WBN-TS-06-09

WATTS BAR NUCLEAR PLANT UNIT 1 - TECHNICAL SPECIFICATION (TS)
CHANGE WBN-TS-06-09 REQUEST FOR ADDITIONAL INFORMATION REGARDING
TECHNICAL SPECIFICATION CHANGE REQUEST FOR ULTIMATE HEAT SINK
TEMPERATURE (TAC NO. MD 1460)

PROPOSED LICENSE AMENDMENT REQUEST WBN-TS-06-09
REVISION OF ULTIMATE HEAT SINK (UHS) TEMPERATURE

Diesel Generator Throttle Valves

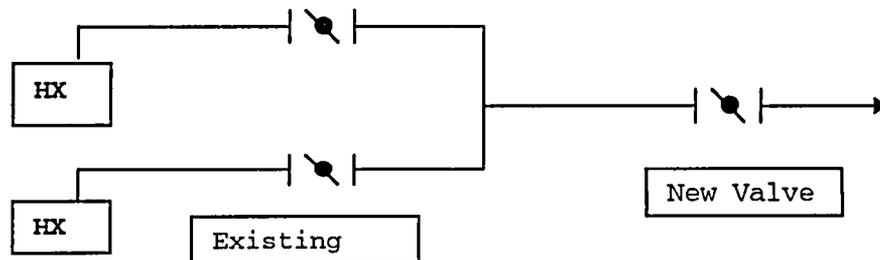
The throttle valves associated with the diesel generator ERCW system accounts for 12 of the changes. TVA implemented a design change to resolve problems with cavitation downstream of the eight existing valves used to throttle flow to the diesel generator jacket water heat exchangers. Each diesel generator has two jacket water heat exchangers. Four new valves were installed in the common discharge piping downstream of the two existing valves. The new valves were adjusted in combination with the upstream valves to reduce the pressure drop across the upstream valves and subsequently, to reduce cavitation in the piping downstream of the existing valves while maintaining the required flow to the heat exchangers as shown in the simplified diagram.

Existing valves: 1-THV-067-0510A, -0510B, -0515A, -0515B; and 2-THV-067-0510A, -0510B, -0515A, -0515B

New valves: 1-THV-067-8020-A, -8021-B; and 2-THV-067-8020-A, -8021-B
